Burlington Design Advisory Board

Design Advisory Board

Tuesday, July 22, 2025, 3:00 PM

To: The Design Advisory Board
From: Mary O'Neil, AICP, Principal Planner
RE: ZP-25-170
Location: 196 South Willard Street
Date: July 22, 2025

Proposed
Conditions
Site Plan

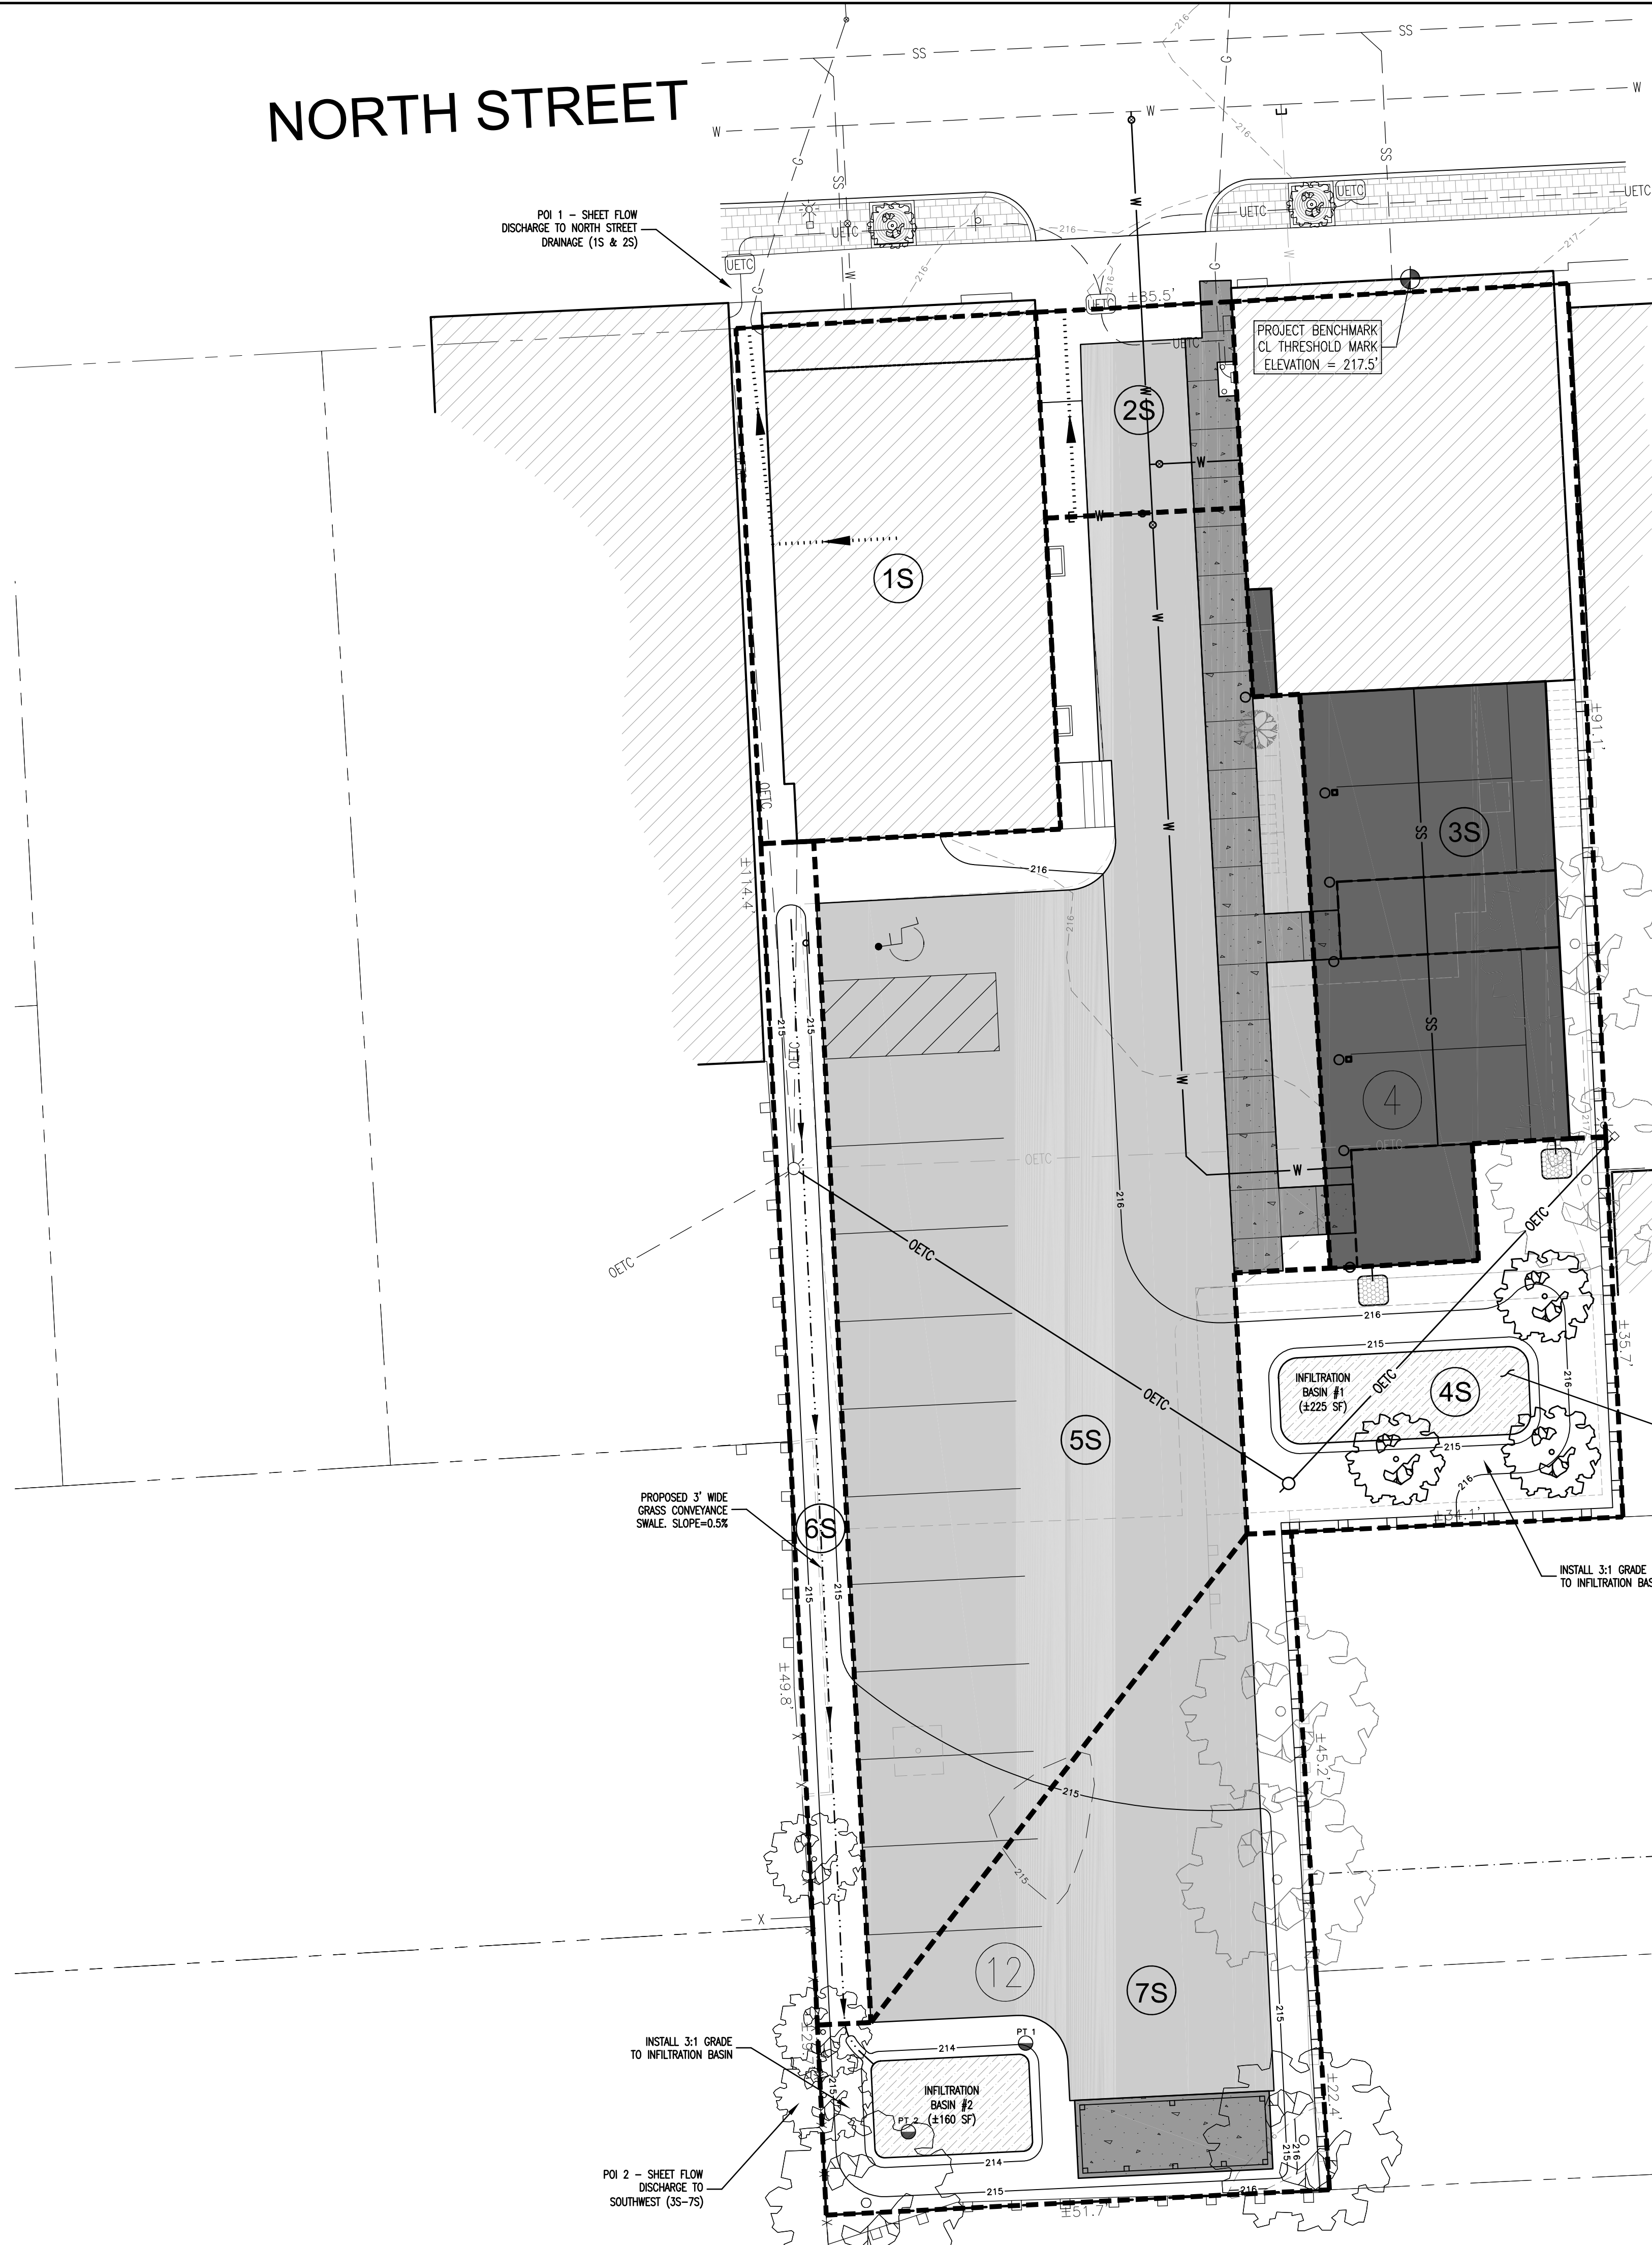
An ADA parking space is depicted on the site plan. It is likely that at least one of the apartments will need to be ADA accessible. Such standards are administered by the Building Inspector through the applicable building codes.

No ground mounted mechanical equipment is depicted in the project plans. Revised project plans depict a trash and recycling enclosure at the south end of the parking area. Enclosure details are needed, as are mailbox locations. The enclosure appears to be closer to the rear property line than previously. A 5 ft. rear yard setback must be observed.

1. Provide complete landscaping plan, including species, location, and size at the time of planting.
2. Depict mailbox location(s).
3. Provide a revised site plan depicting curb stops for all parking spaces.

LANDSCAPE
PLAN

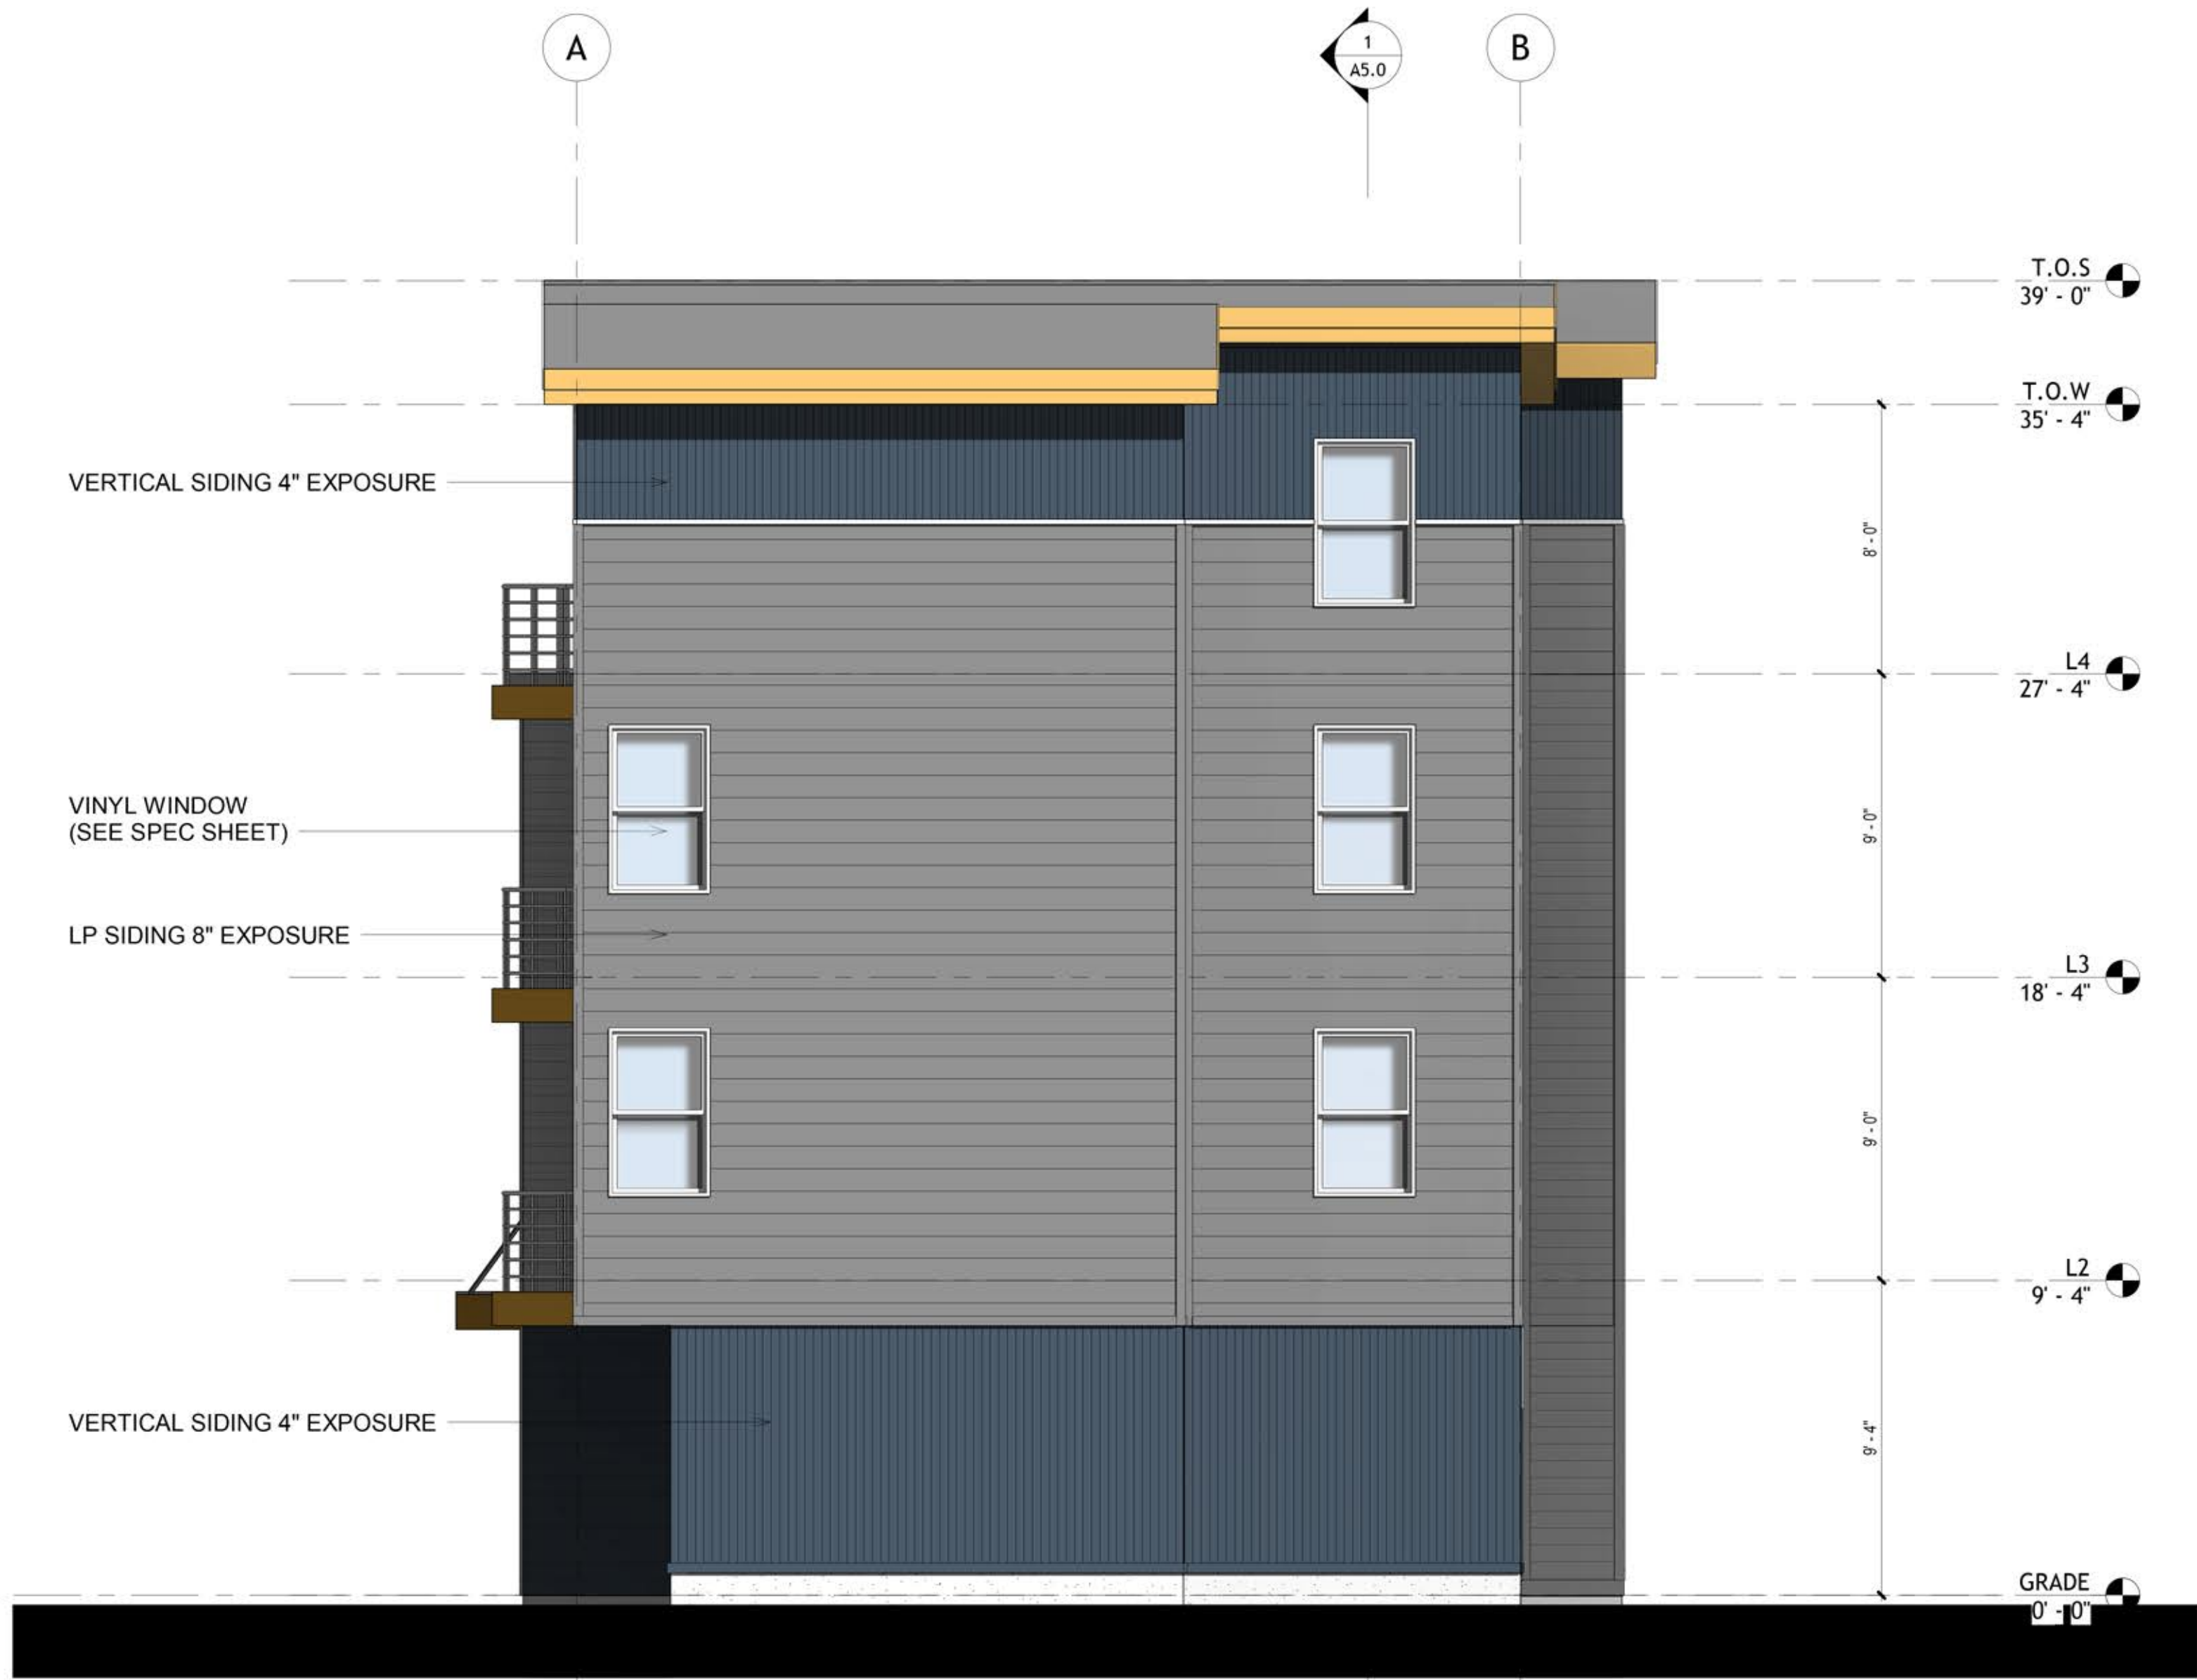
The amended application contains no specific landscaping plan and should. The landscape icons appear to match what was included in the prior project, and there is one notation of a new autumn blaze maple. A landscaping plan is needed and must include species and size of plantings at the time of installation. The new project plans contain two detention basins for stormwater. There is opportunity here to provide landscaping appropriate for rain gardens in these two basins. No new fencing is proposed, except that a stretch of existing fencing along the eastern side property line will be replaced in-kind. No retaining walls are proposed.

NORTH ELEVATION

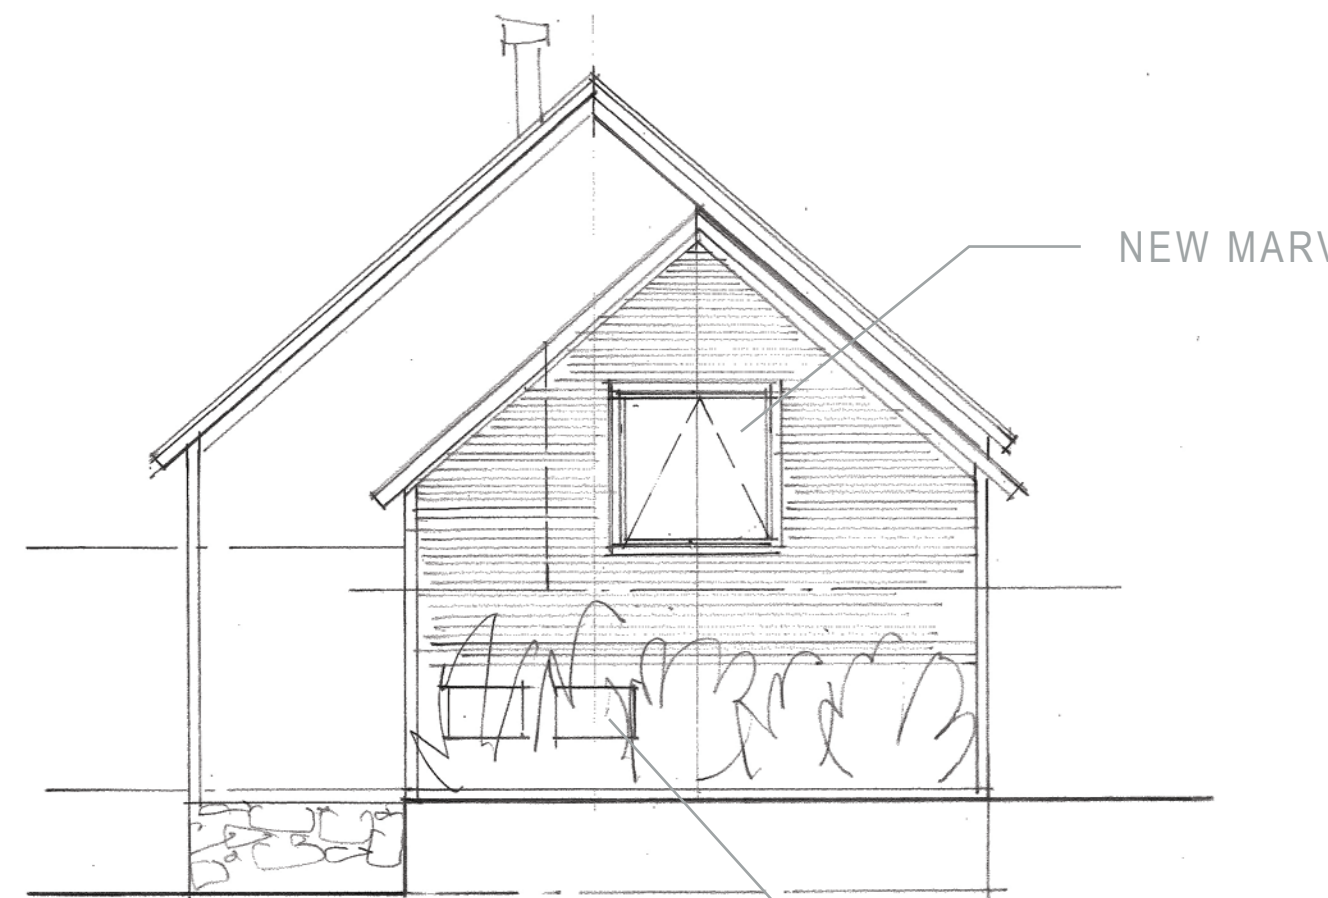
There appears to be some manipulation of the grade at the north elevation entrance point, where a ramp was previously proposed. Additionally, the grade change on the west (where the basement garage door was) is now represented as gravel/pavement.

A recessed entry is planned on the north elevation, with an entry door that mimics vertical paneling.

L000

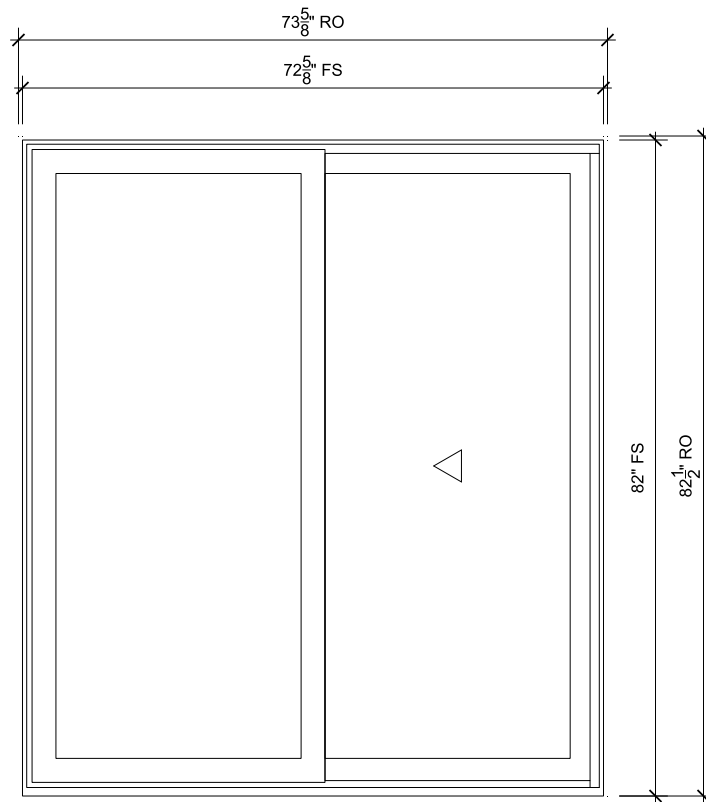
An existing tree is proposed to be retained; however from the most recent site plan, it appears to be within the public ROW. See Plan L000.

The applicant has been informed that the previous lot coverage approval (49%) cannot be exceeded, as it is non-conforming. Plan L000 defines lot coverage at 47.3%.

The revised plan (L000) expands the parking at the site, in excess of the 18' limitation for driveway width as defined in the ordinance. Although widened pavement was approved under ZP-19-0645CA, it was limited to the access at the basement west garage door area and 20' in length. (The basement access door has been removed in this plan.)

An existing tree adjacent to the carriage barn will be retained, however from the revised plan, that tree is within the ROW.
